EL PASO COUNTY PLANNING & COMMUNITY DEVELOPMENT SIGN APPLICATION

Name: Big O Tires
Address: 5820 OMAHA BLVD
Colorado Springs, CO 80915
Zone: _____
Legal Description: _____

Sign Plan

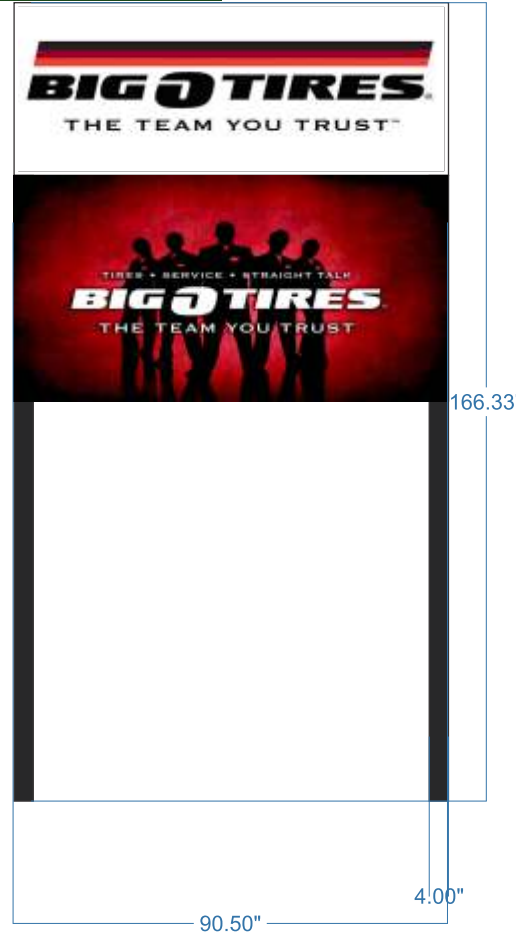
I need to see a site plan of the property, showing the structure and where the sign is going to go. This can be on the attached sign plan. There are setbacks that need to be met in order to approve this sign.

The plat shows a 10 foot utility easement where I believe this sign is being proposed. Please show on the site plan that the proposed easement is not located in the easement (No sign may be erected in placed on or extended over a utility or drainage easement unless approved in writing by the entity or entities having jurisdiction over the easement. Land Development Code 6.2.10.D.c.)

You can't place the sign in the drainage way.
